MEMORANDUM

November 8, 2019

TO: MELISSA PLACE
FROM: COSTCO DESIGN TEAM
RE: Costco Responses to Lider and Whipple Comment Letters

This Memorandum collects responses from Costco’s wetland, stream, traffic, geotechnical and stormwater consultants who have reviewed and provided responses to the October 7, 2019 William Lider, PE, CESCL (“Lider”) and October 15, 2019 Michael D. Whipple (“Whipple”) comment letters.

Figure 18: Need for East-West Connector Roads

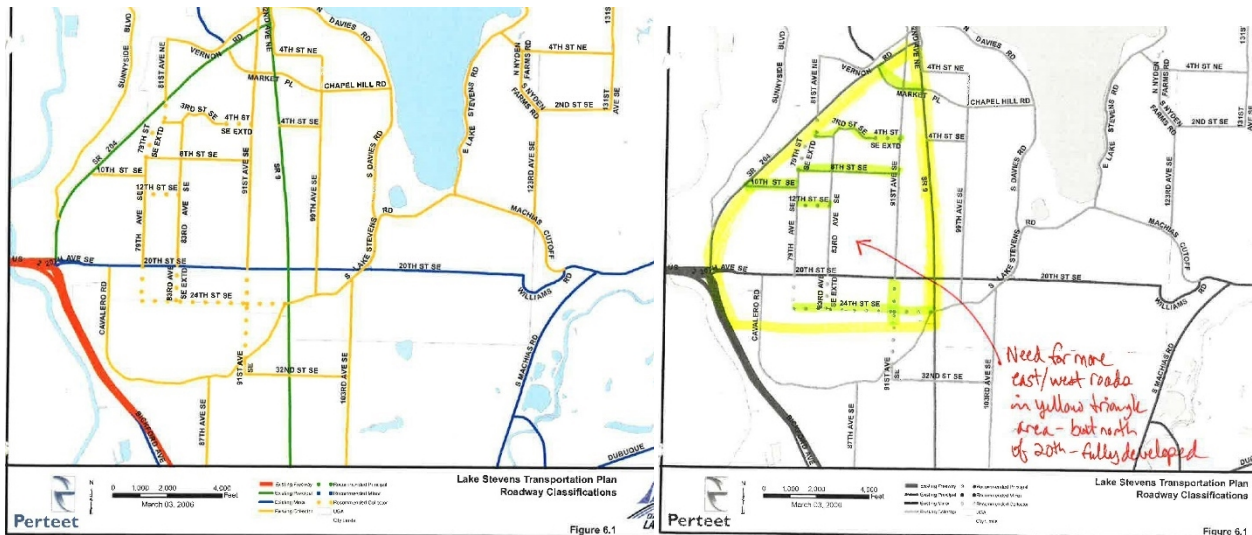
Regarding the need to construct 24th Street SE, the Alternatives Analysis provides the following discussion:

The addition of 24th Street SE is a logical east-west connector within the City’s transportation system. The City lacks major east-west connectors, putting traffic pressure on the few existing connectors in the southern half of the City; 20th Street SE, 12th Street SE, 8th Street SE, and Market Place; none of which, except 20th Street SE, fully extend from SR-9 to SR-204 (see below maps).

Proposed 24th Street SE is a much-needed parallel alternative to 20th Street SE, helping to reduce traffic congestion on 20th St SE, some of which has been generated by recent housing development in the area and pass-by trips from outside the City limits. The possible location for 24th Street SE is constrained to the south by current City limits and the Puget Sound Energy power transmission line, wetlands and a Mosher Creek tributary, and to the north by the City of Everett waterline corridor (just south of 20th Street SE). The properties north of 20th Street SE are fully developed, precluding the location of a new east-west road spine.
